# Access Compliance Report

## Public Rights-of-Way

Intersection ID: 15799	Main Street: MARION_PL	Cross Street: MELBOURNE_CT	Location: E
ADA ID: B6BEE0A494A0	Ramp Type: PerpDiag	Initial Pass/Fail: Fail	Overall Compliance: No
Severity Score: 1.25			
Codes/Mitigation Info/Possible Solution		Field Measurements/Component Compliance

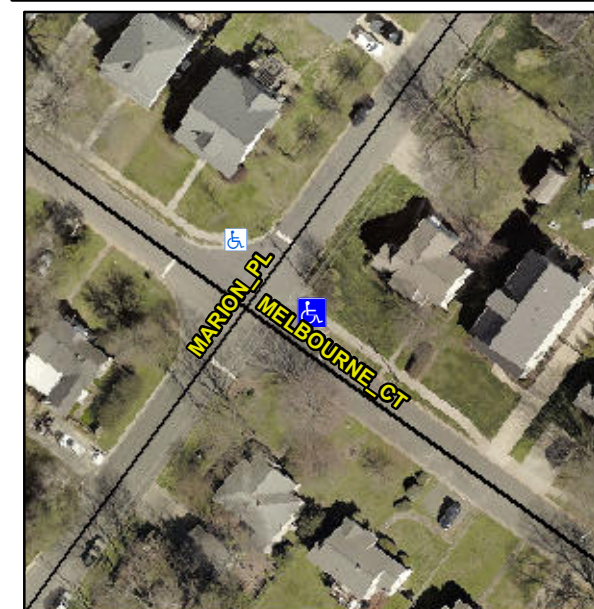
**Not Found, R304.5.3**

Compliance	Description	Data	Compliance	Description	Data
N/A	Ramp Length (in)	31.0	Yes	Ramp Slope (%)	5.1
Yes	Ramp Width (in)	48.0	No	Ramp XSlope (%)	2.3
N/A	Flare Type LT	N/A	N/A	Flare Type RT	N/A
N/A	Flare Slope LT (%)	N/A	N/A	Flare Slope RT (%)	N/A
N/A	Flare Traversable LT?	N/A	N/A	Flare Traversable RT?	N/A
N/A	Landing Length (in)	N/A	N/A	DWS Provided?	N/A
N/A	Landing Width (in)	N/A	N/A	DWS Contrast?	N/A
N/A	Landing Slope (%)	N/A	N/A	DWS Length (in)	N/A
N/A	Landing X Slope (%)	N/A	N/A	DWS Full Width?	N/A
N/A	Landing Curb? (Y/N)	N/A	N/A	DWS Offset (in)	N/A
N/A	Shared Landing?	N/A			
N/A	Gutter Ponding?	N/A	N/A	Gutter Slope (%)	N/A
N/A	Gutter Lip Ht (in)	N/A	N/A	Gutter X Slope (%)	N/A
N/A	Painted X Walk1?	No	N/A	Painted X Walk2?	No
	X Walk 1 Direction	To NW		X Walk 2 Direction	To SW
N/A	X Walk 1 Width (in)	N/A	N/A	X Walk 2 Width (in)	N/A
	X Walk 1 Slope (%)	1.9		X Walk 2 Slope (%)	1.0
	X Walk 1 X Slope (%)	1.1		X Walk 2 X Slope (%)	0.6

**Remove & Replace Curb Ramp With Two New Directional Ramps or Equivalent.**
